### PUBLIC WORKS COMMITTEE INQUIRY AUSTRALIAN WAR MEMORIAL DEVELOPMENT PROJECT

#### Submission details:

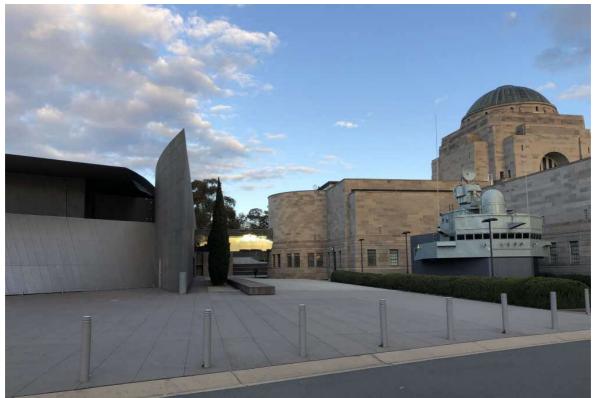
Nowhere does the Australian War Memorial give evidence that this stated purpose needs to occur at the current site at the head of Anzac Parade. The stated purpose could be equally, or better, served at a nearby or appropriate other location.

It is a pity, for example, that the Australian War Memorial Council, who have been planning expansion strategies since 2015, did not acquire the former CSIRO headquarters site, only 500 metres away, for \$20 million when it was on sale in 2016. This elegant elevated site could have provide ample space for expansion without compromising the existing serene character of the memorial or involving the demolition of Anzac Hall.
